PROCEDURE NUMBER: OP-010-005

TITLE: Plant Shutdown

**DESCRIPTION AND JUSTIFICATION OF CHANGE:**

## 9.14 RCS PRESSURE AND TEMPERATURE LIMITS

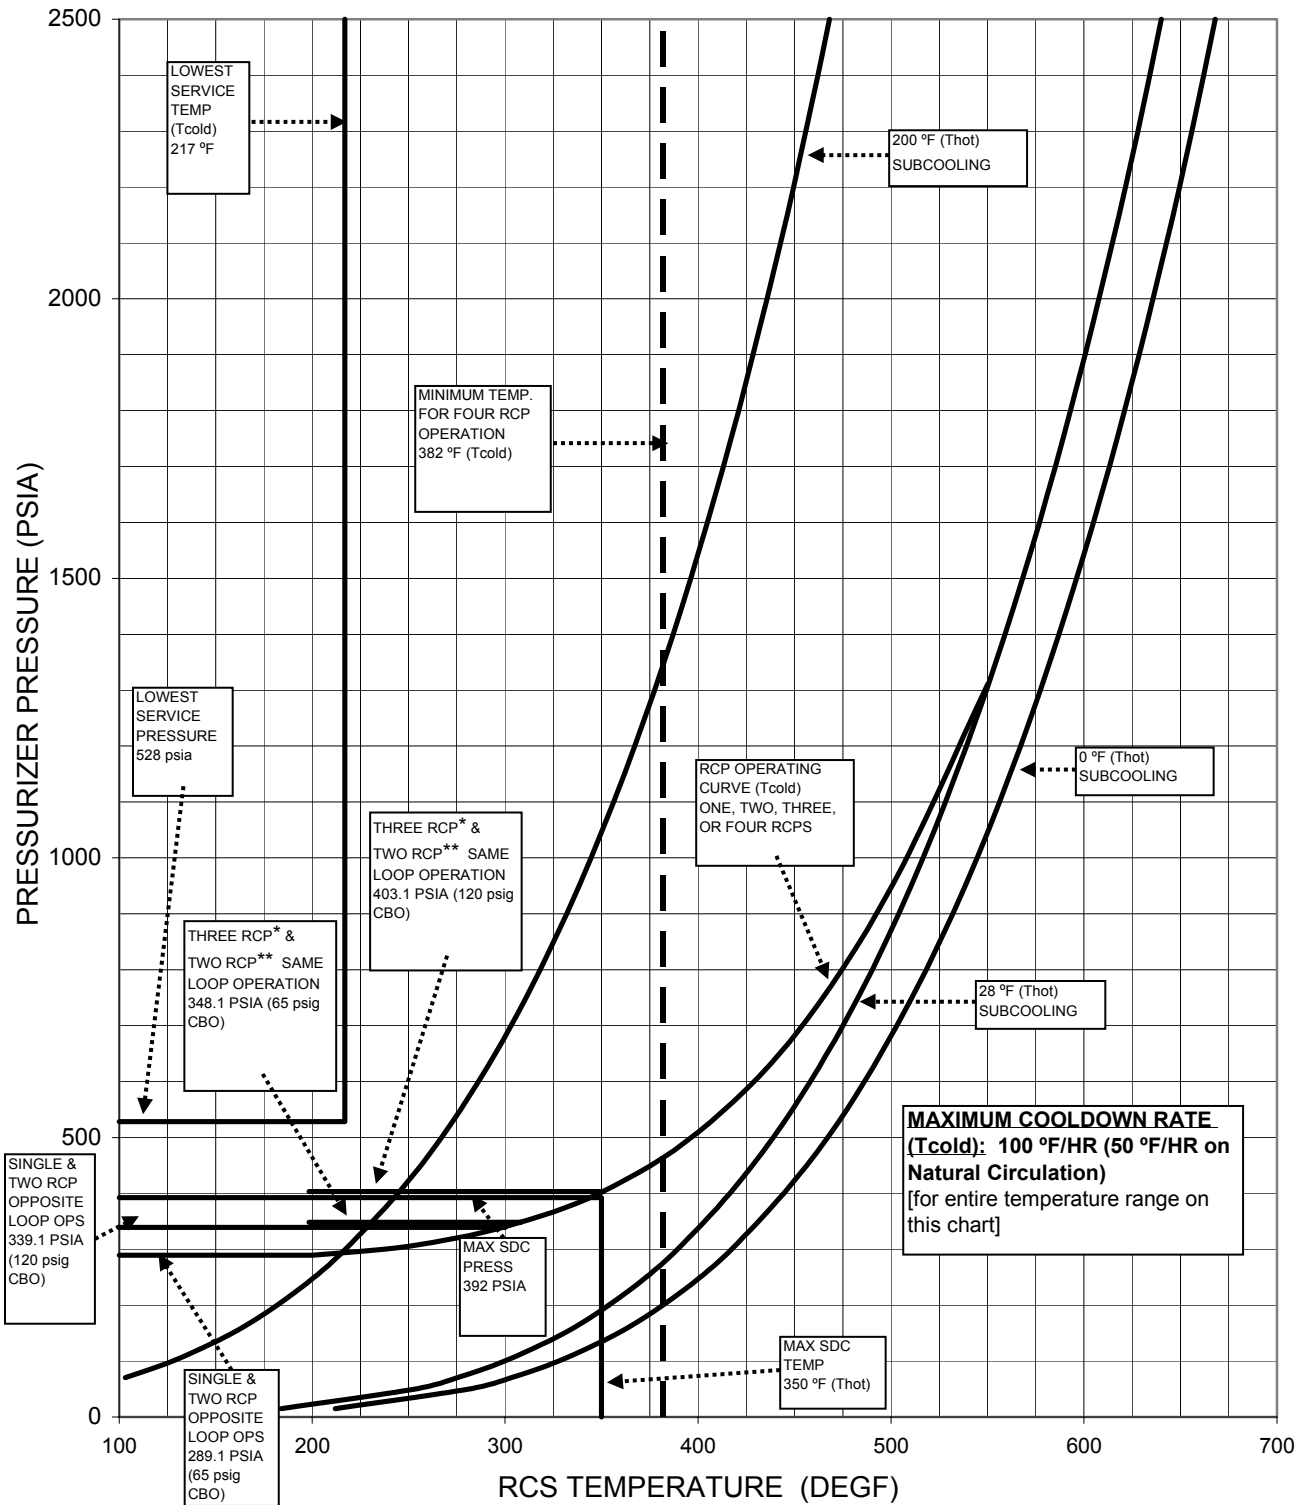
In Attachment 9.14 changed values in notes for lower temperature limits for Reactor Coolant Pump (RCP) operations on both the narrow view and the expanded view graphs as follows: changed 219 degrees Fahrenheit to 199 degrees Fahrenheit for three RCP operation; changed 192 degrees Fahrenheit to 172 degrees Fahrenheit for two RCP operation; changed the RCP 2A operational limit changed from 367 degrees Fahrenheit to 347 degrees Fahrenheit. The revised values accord with Figures 1A and 1B in the latest approved version of EC-S98-001 (DRN 03-2208). The values were already correct on the expanded view graph but were wrong on the narrow view graph. These changes are corrections of reference values and meet Editorial Change criteria per EN-AD-101 section 3.0[4](b).

\* Not allowed below 199°F and RCP 2A operation not allowed below 347°F.
